### NEPEAN HEALTH PRECINCT MIXED USE DEVELOPMENT

#### PREFERRED PROJECT REPORT

CONCEPT PLAN (MP09\_0197)
STAGE 1 PROJECT APPLICATION (MP09\_0220)

SUBMITTED TO: DEPARTMENT OF PLANNING ON BEHALF OF AESTHETE NO. 3

FIGURE 2: EXTRACT OF COUCNILS PLANNING PROPOSAL

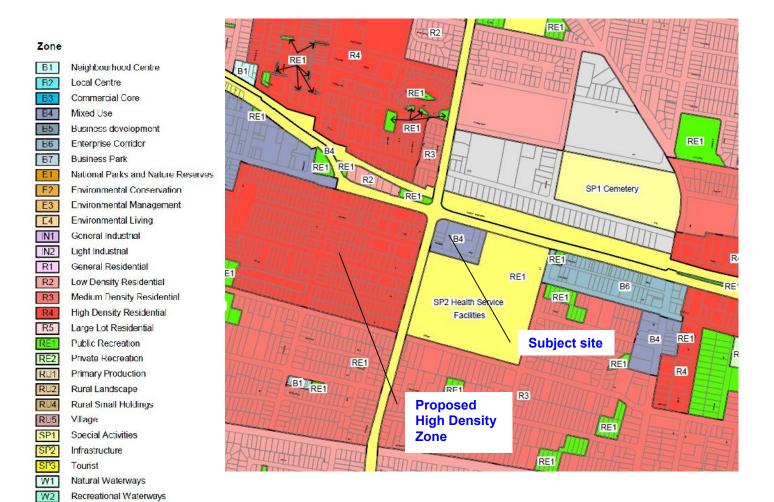
"The scale of the residential component of Stage 2 of the Concept Plan is considered inappropriate given the existing medium density zoning of the site, the height of the existing Nepean Private Hospital building and the context of surrounding low density residential areas. The height of the Stage 2 building should be significantly reduced and buildings within Stage 1 should be a maximum of 6 stories above natural ground level."

The most relevant of these is the fact that Penrith City Council have prepared and forwarded a Planning Proposal to the Department of Planning that seeks to zone the lands to the immediate west of the subject site as High Density. An extract of the relevant zoning map that accompanies that Planning Proposal is provided at Figure 2.

FIGURE 5: EXTRACT OF LANDSCAPING PLAN

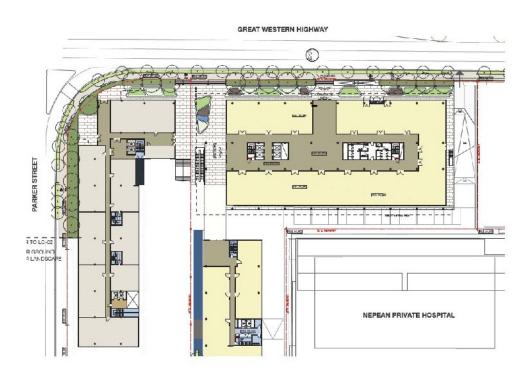
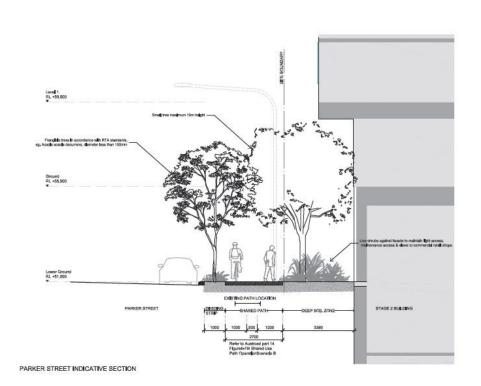
An unsatisfactory standard of urban design is achieved as a result of poor pedestrian and bicycle linkages both within the subject site and leading to the site, insufficient provision of landscaping along public frontages and within the plaza, excessive height, bulk and scale, and inadequate building articulation.

However, the PPS also provides an amended landscape plan that provides enhanced landscape provision within the pedestrian plaza as well as the provision of mature street trees to the frontage of both Parker St and the Great Western Highway. The provision of mature trees at the Highway frontage is facilitated by the significant building setback provided at this location. The enhanced landscaping as well as improved landscaping to Great Western Highway, Parker St and Plaza is represented within the accompanying landscape plans (Annexure C) and exerts of those plans at Figure 4-6.
